SUBJECT: MILLSTONE POWER STATION, UNIT NO. 3 - ISSUANCE OF RELIEF FROM
CODE REQUIREMENTS (TAC NO. MC8609)

SAFETY EVALUATION BY THE OFFICE OF NUCLEAR REACTOR REGULATION

RELATED TO RELIEF FROM ASME CODE REQUIREMENTS

MILLSTONE POWER STATION, UNIT NO. 3

Figure 1 – MPS3 Typical Weld Overlay Repair Configuration

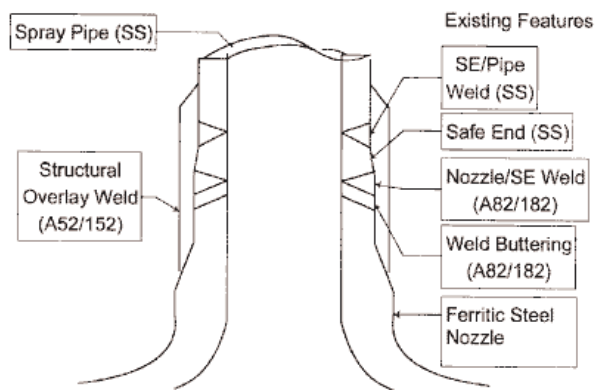
A full structural weld overlay repair is proposed for the pressurizer spray nozzle to safe end HSS dissimilar metal weld (Weld No. 03-X-5641-E-T) with unacceptable indications in the existing Alloy 82/182 weld material. The application of this relief request will include the adjacent acceptable stainless steel safe end to pipe weld (Weld No. RCS-517-FW-12). For (Weld No. 03-X-5641-E-T) the nozzle material is ferritic steel (P3). The pipe is austenitic stainless steel (P8). The existing weld filler material is Alloy 82/182 (F43 equivalent to P43). The overlay will be designed as a full structural overlay in accordance with ASME Section XI Code Case N-504-2 and Nonmandatory Appendix Q (Reference 3). The temper bead welding technique will be implemented in accordance with ASME Section XI Code Case N-638-1 (Reference 4) for that portion of the overlay applied over the ferritic base material for which the Construction Code requires post-weld heat treatment. Temperature monitoring requirements contained within this Code Case will be performed using contact pyrometers in lieu of thermocouples required by IWA-4610(a) of the ASME Code, Section XI 1998 Edition with no Addenda (Reference 1). This full structural weld overlay satisfies all the structural design requirements of the pipe as if the pipe were not there. As shown in Figure 1 below, this structural weld overlay (weld reinforcement) will completely cover the existing Alloy 82/182 weld metal and will extend onto the ferritic and austenitic stainless steel material on each end of the weld, including the adjacent acceptable weld (Weld No. RCS-517-FW-12). Although the weld overlay extends the full 360° around the nozzle, only half is shown in Figure 1 for clarity.

During the fall 2005 refueling outage at MPS3, unacceptable indications were discovered in one HSS Class 1 reactor coolant system (RCS) pressurizer spray dissimilar metal nozzle to safe end weld (Weld No. 03-X-5641-E-T). The indications were discovered as a result of examinations performed in accordance with the MPS3 RI-ISI program and the licensee's response to NRC Bulletin 2004-01. The licensee stated that the examination of weld 03-X-5641-E-T included both RT and UT. The UT examination was performed to the extent practical, using techniques and procedures approved under the PDI. The adjacent stainless steel safe end to stainless steel spray pipe weld (RCS-517-FW-12) was determined by the licensee to be acceptable after receiving a PDI-qualified manual UT examination. The indications in weld No. 03-X-5641-E-T were initially discovered by RT and later fully characterized by PDI qualified automated UT. The licensee indicated that it located and characterized three flaws. Two of the flaws are circumferentially oriented and contain characteristics that indicate that they are fabrication flaws. The third flaw is axial, and although it could be a fabrication flaw according to the licensee, the NRC staff notes that PWSCC cannot be excluded as a possible cause of this flaw. The flaws were located in the Alloy 82/182 weld metal which is known to be susceptible to PWSCC. In the relief request, the licensee proposed a weld overlay repair plan which consists of the use of ASME Code Case N-504-2 with non-mandatory Appendix Q, with modification, and in lieu of the weld-attached thermocouple requirements and recording instruments in ASME [Code] Section XI 1998 Edition, no Addenda, IWA-4610(a), the licensee will use contact pyrometers and manual recording of the process temperatures. ASME Code Case N-638-1 will be used in its entirety with the exception that Section 4.0(b) will not be met. The weld overlay repair plan is proposed as an alternative to the ASME Code requirements in IWA-4000. For the inspection of the weld overlay, the licensee proposed the use of the PDI program as an alternative to the ASME Code requirements of Section XI, Appendix VIII, Supplement 11. The NRC staff has evaluated the licensee's bases for the proposed alternatives as provided in the licensee's submittal and supplemental information provided.

The NRC staff notes that both code cases are approved for use by the NRC in Regulatory Guide (RG) 1.147, Revision 14, with conditions. Although the licensee has requested to use the aforementioned code cases with modifications, it intends to adhere to the conditional requirements specified in RG 1.147, Revision 14. Both code cases, with conditions, provide acceptable alternatives to the ASME Code requirements. The licensee's proposed alternatives and their basis are provided in Tables 1, 2 and 3 of its relief request. A sketch of the overlay repair is shown below in Figure 1, which is taken from the DNC's October 19, 2005, submittal. The NRC staff's evaluation of the licensee's proposed alternatives relating to the relief/modifications to ASME Code, Section XI of IWA-4000, ASME Code Case N-504-2, ASME Code Case N-638-1 and ASME Code, Section XI, Appendix VIII, Supplement 11 are provided below:

The NRC staff has reviewed the licensee's submittal and determined that the proposed alternatives will provide an acceptable level of quality and safety. Therefore, pursuant to 10 CFR 50.55a(a)(3)(i), the NRC staff authorizes the use of the proposed alternatives to IWA-4610(a), ASME Code Cases N-504-2 and N-638-1 for the weld overlay repair of weld 03-X-5641-E-T and adjacent weld RCS-517-FW-12, during the 2005 fall refueling outage at MPS3. In addition, pursuant to 10 CFR 50.55a(a)(3)(i), the NRC staff authorizes the use of the proposed alternative to use the PDI protocol of implementing of Appendix VIII, Supplement 11, in lieu of the ASME Code, Section XI, for the remainder of the second ISI interval at MPS3.
